Problems with Falcon Stainless Steel Exhaust Systems

Sometime back I asked the list if anyone had discovered a stainless exhaust system that fit with a minimum of problems. The consensus was that Falcon Systems appeared to have their quality control issues straightened out. So I ordered a system From a Moss distributor. Here's what I found, starting at the front:

Photo 5 pipe interference

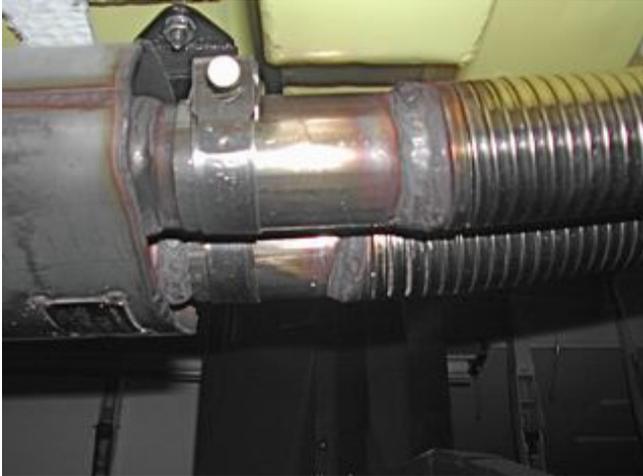
#Photo 1. Flange is welded on exhaust pipe crooked. The forward pipe from the manifold to the muffler has the flange welded on crooked, swinging the pipe inward. It jams against the rear pipe and won't allow the flange to lay flat against the manifold. I only found this out after having to file the flange holes to get it on the manifold.

Photo 4 Pipe interference

Remedy: Heat pipe just below the flange and pull it out bit by bit. Also see photos 4 and 5.

Photo 9 My homemade bracket

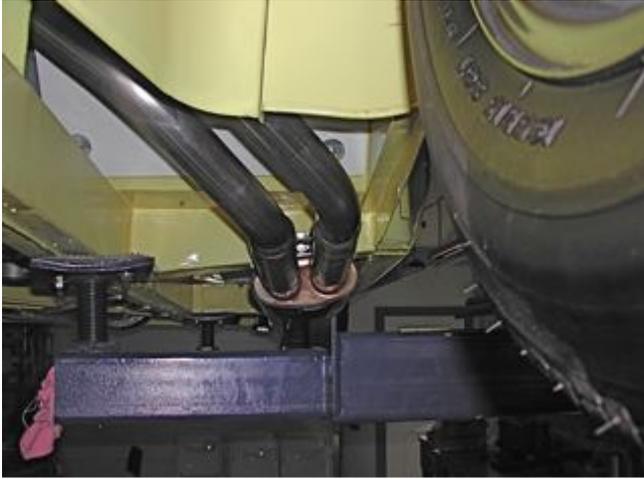
Photo 2 Bracket stud is about 1" off center. The Falcon hanger at the rear of the muffler/front of the tail pipes is off-center with a bolt welded in. My old pipes had the bracket hole centered between the pipes, I can't move the pipes over as the muffler hits the rocker and the pipes won't lay in the relief in the outrigger.

Photo 8 Falcon bracket location

Remedy: Saw off Falcon bracket. Make up a bracket to clamp both pipes with a stud on center. See also photos 3, 8, 9 and 10.
